Application of The Varner Group c/o Bejune Industries to rezone property from C-1 (Local Commercial) zoning district to RSM (Residential Medium Lot) zoning district to construct a townhome community, at 6826 Covington Highway.

PETITION NO: D1-2023-1431 Z-24-1246747

Z-24-1246747 (2023-1431)
Recommended Conditions – May 2024
6826 Covington Highway

STAFF ANALYSIS

SITE PLAN 04/19/2024

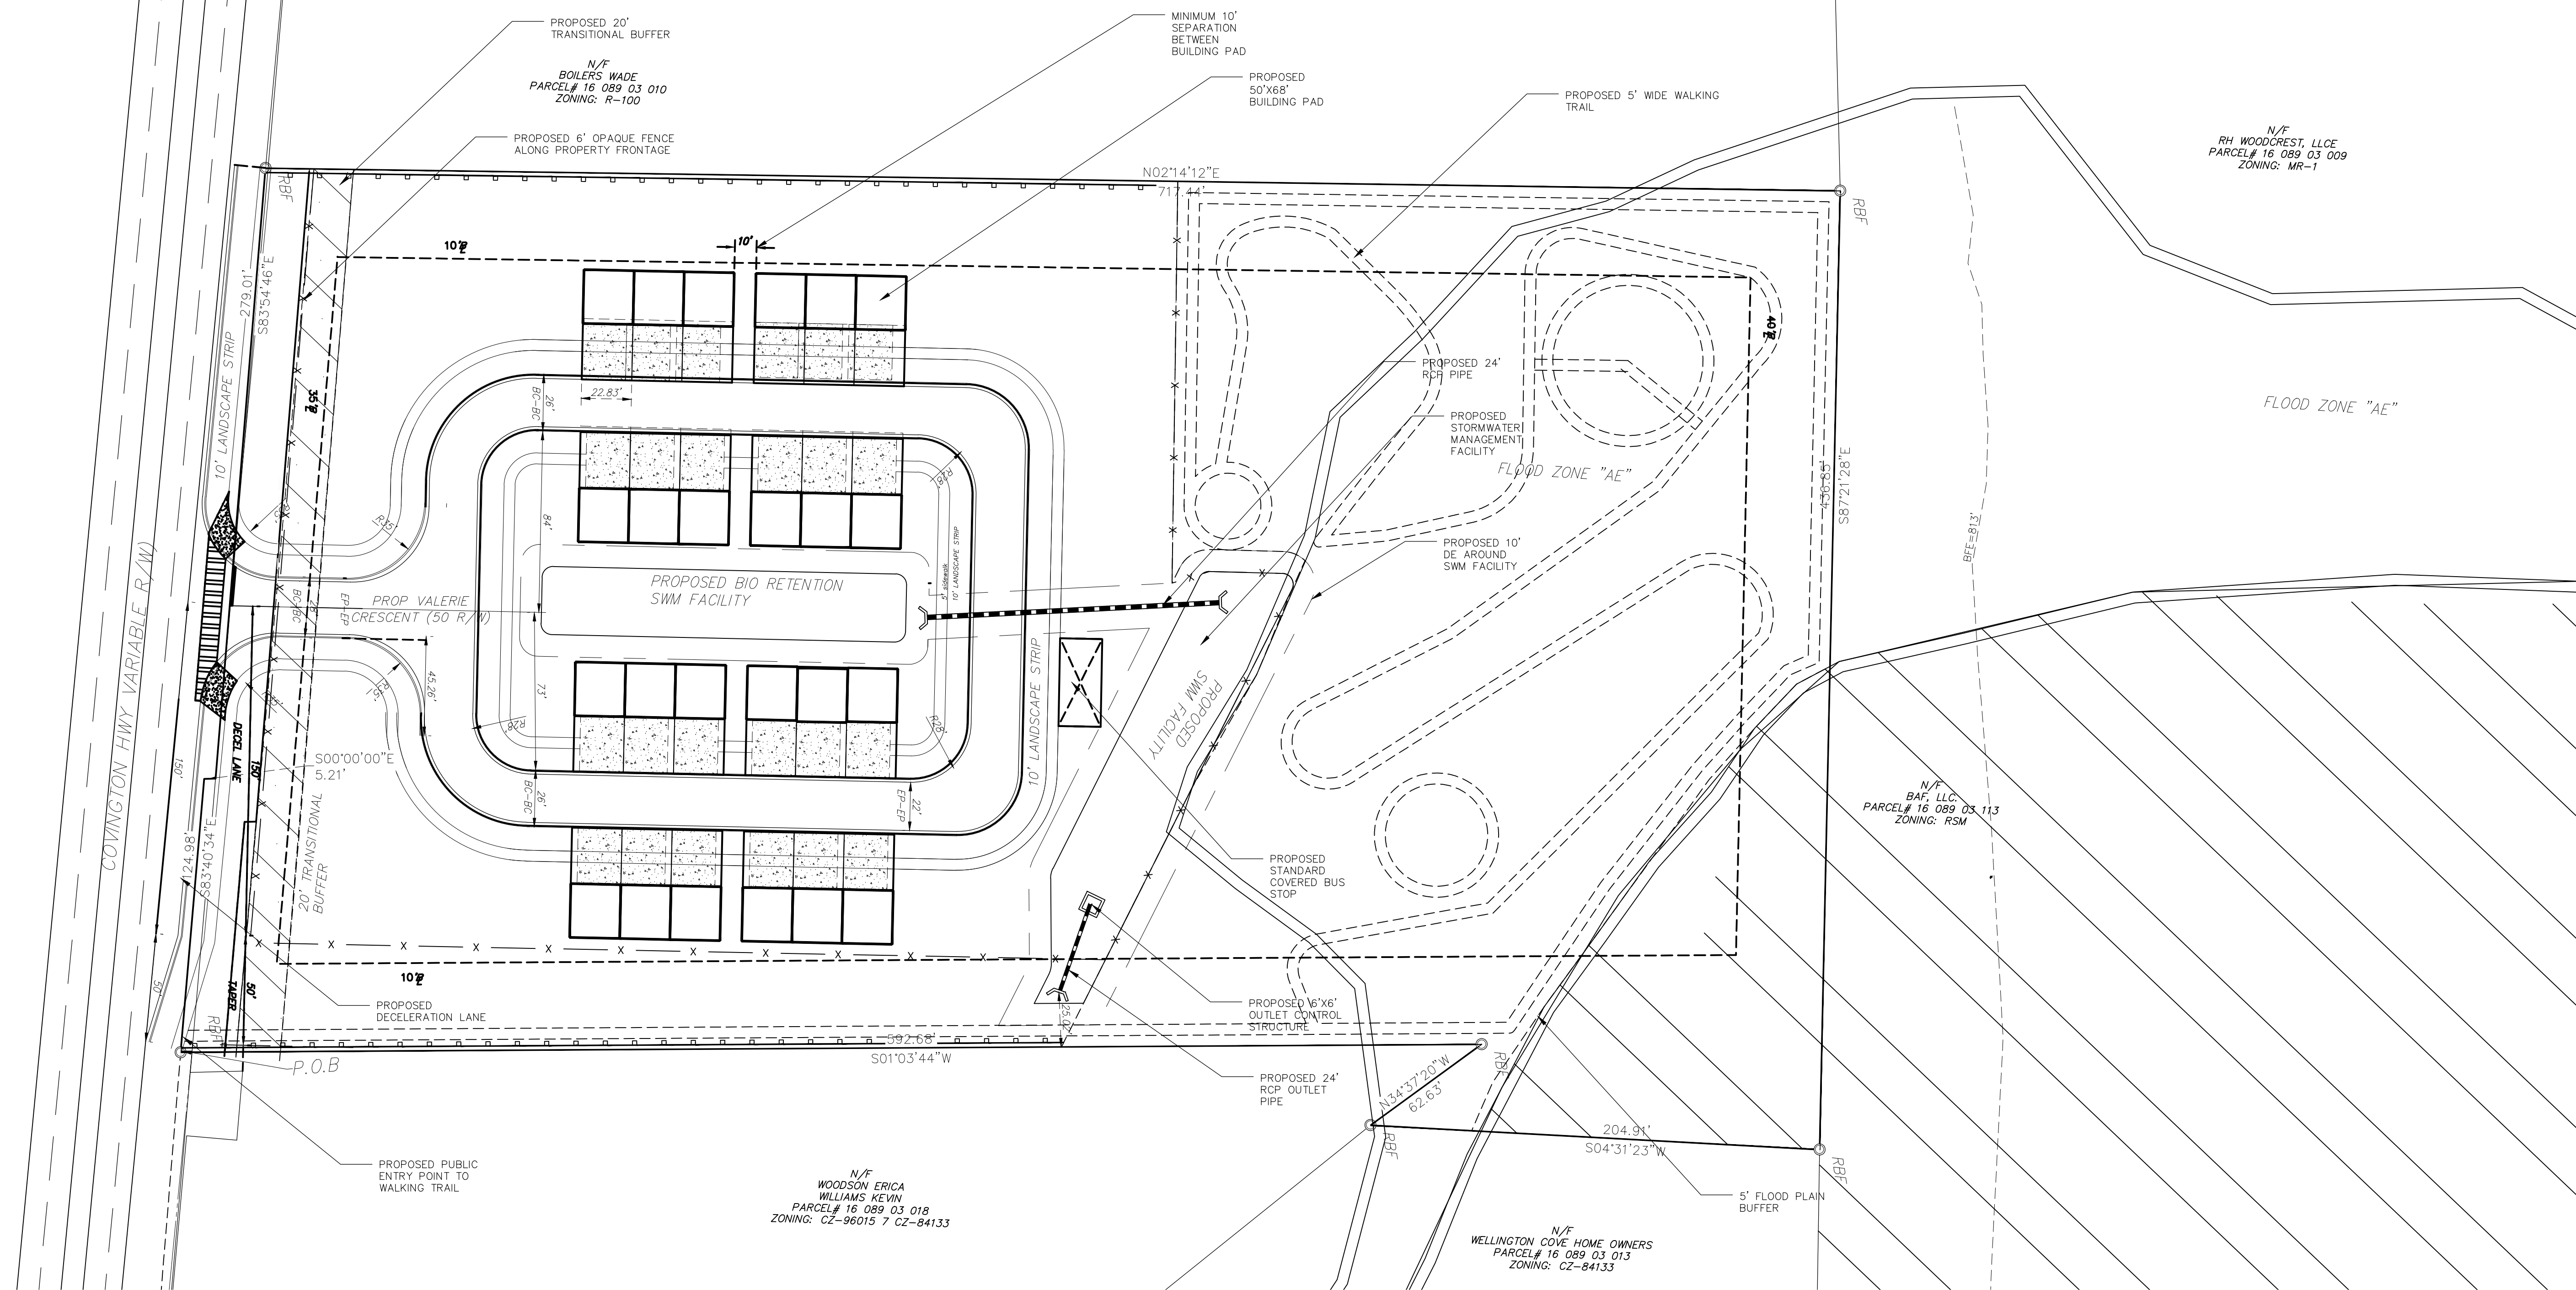
The applicant's proposal and associated site plan have undergone significant changes since. The most recent site plan, dated April 19, 2024, proposes up to 40 single-family, attached, dwelling units that are to be developed as condominiums.

The proposal demonstrates strong adherence to street connectivity standards per Sections 5.3.2. and 5.7.6. of the *Zoning Ordinance*. The majority of units have rear-loading garages made accessible by a network of alleys, and have front facades facing public streets - or private streets that are to be constructed to public street standards. Significant detail has been made to show pedestrian connections – a ten (10)-foot multimodal path is proposed along the entirety of the development site's frontage on Covington Highway, and interior streets all feature sidewalks and connections to proposed amenities. Landscaping in association with these pedestrian paths is provided that will ensure an aesthetically pleasing, safe, and welcoming environment at the pedestrian level.

A minimum of 20 percent of the development site shall be developed with open space in mind; half of this, or ten (10) percent of the site, shall be developed with enhanced open space. Amenities such as a clubhouse, gazebo, and a central common area are proposed, as is a system of mulch trails that will traverse the rear of the development site. These trails are located within a 100-year floodplain, and a portion of the subject property contains state waters. At this time, minimum open space and enhanced open space requirements appear to be met but may not properly depicted on the site plan. Yards shown in front or to the side of units are depicted as enhanced open space, which do not qualify as such, whereas the proposed system of trails that are not labeled as being enhanced open space, most likely do.

Correspondence with other County departments has indicated that many of the original site plan's deficiencies appear to have been adequately addressed with the most recent site plan. While the proposal may be subject to minor changes to comply with other departments' requirements at the Land Development Permit (LDP) phase, Planning Staff concludes that the most recent proposal demonstrates exceptional compliance with design standards for a single-family, attached, development, and said development and associated rezoning request is consistent with the intent of the CRC Character Area and the *DeKalb 2050 Unified Plan*. Therefore, the Planning and Sustainability Department recommends *Approval with Conditions*.

1. Development of the site shall be in general conformance with the site plan titled “6826 Covington Highway” and dated April 19, 2024. The site plan is conceptual, however, and wherever the site plan conflicts with the development standards of the *Land Development Code, Zoning Ordinance*, or other applicable ordinances, said ordinances shall prevail.

5. A minimum of 20 percent open space shall be provided within the development site. At minimum, half of this, or a minimum of ten (10) percent of the development site, shall be enhanced open space. A separate sheet shall be provided with LDP and Final Plat plans that consist of a site plan adequately highlighting open and enhanced open space (by color-coding, shading, or similar method). A tabular breakdown shall be provided showing the square footages of each open and enhanced open space area with callouts of the locations of these areas. No more than 50 percent of required open space may consist of floodplain, wetlands, steep slopes, streams and buffers. A maximum five (5)-foot-wide mulch walking trail shall be provided in general conformance to the attached site plan.

SITE PLAN 12/13/2023

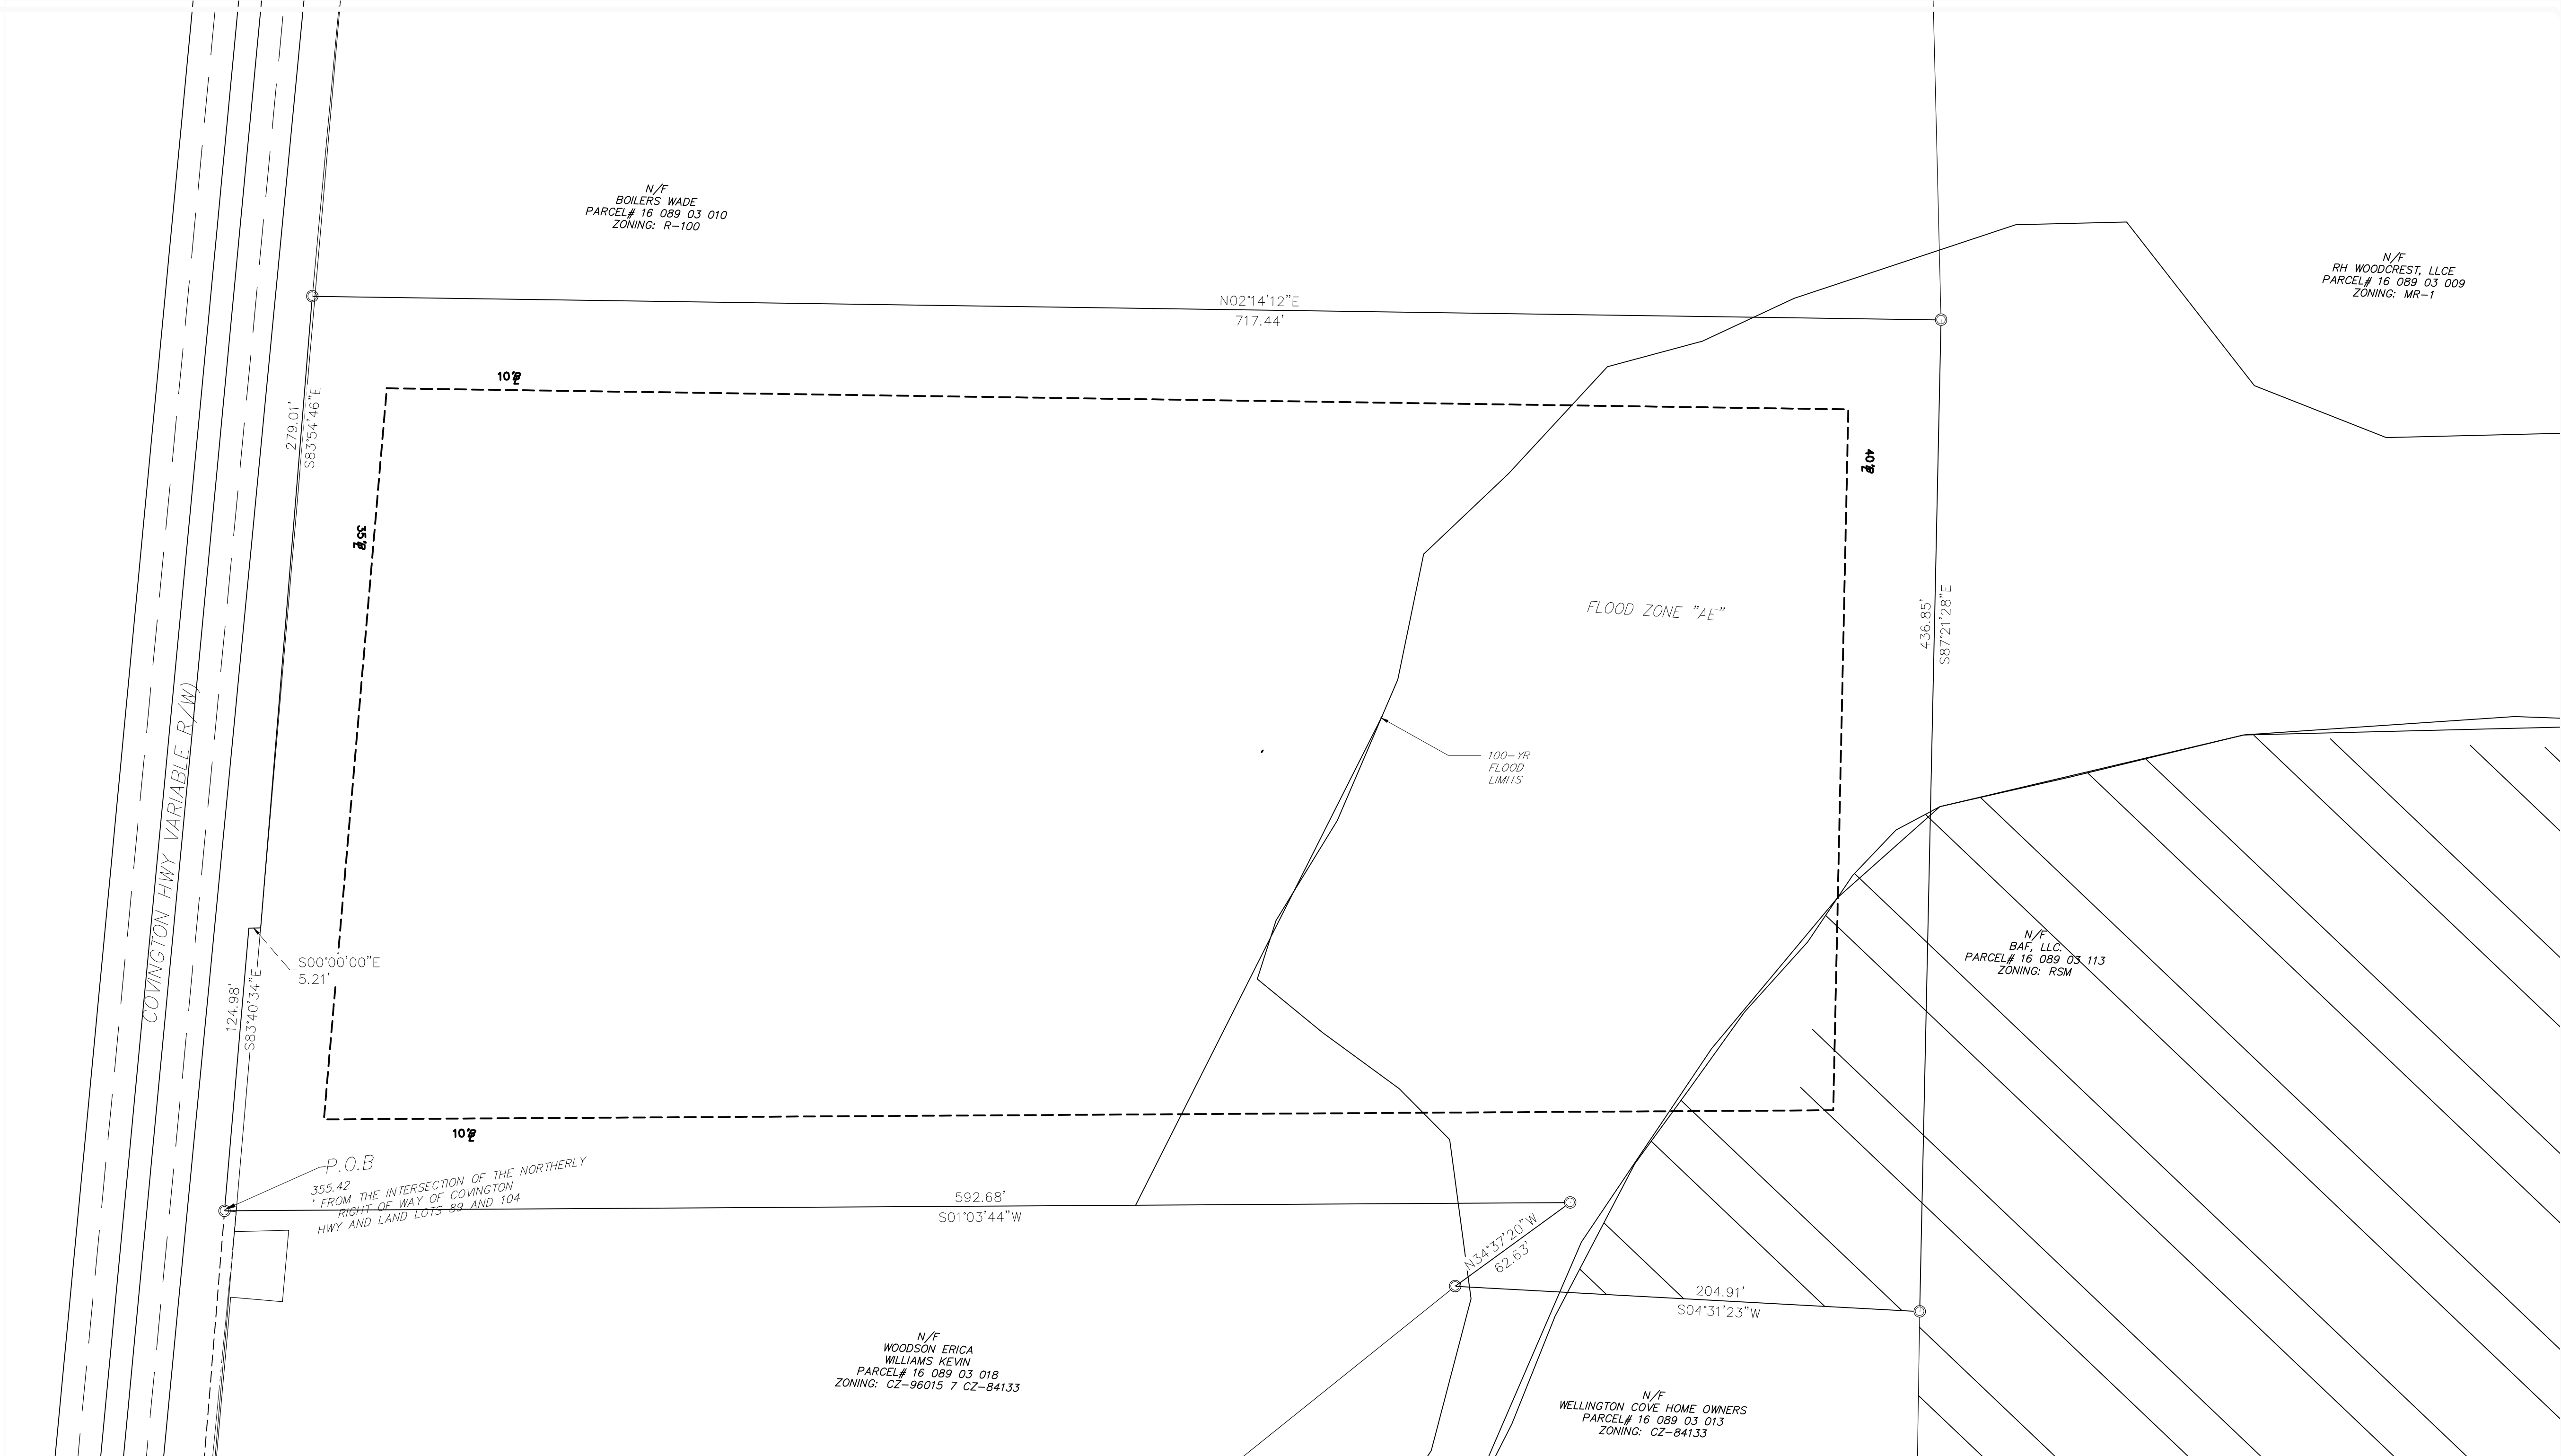
The original site plan, however, lacked sufficient detail (e.g., incorrect setbacks, density calculations, and open space calculations). Additional deficiencies were noted by other regulatory agencies including Land Development, Roads and Drainage, Transportation, and Watershed Management. In order to address departmental concerns and

adjust the site plan accordingly, both Planning Staff and the Planning Commission recommended a *Two-Cycle Deferral*, which was granted by the Board of Commissioners at a public hearing held on January 25, 2024.
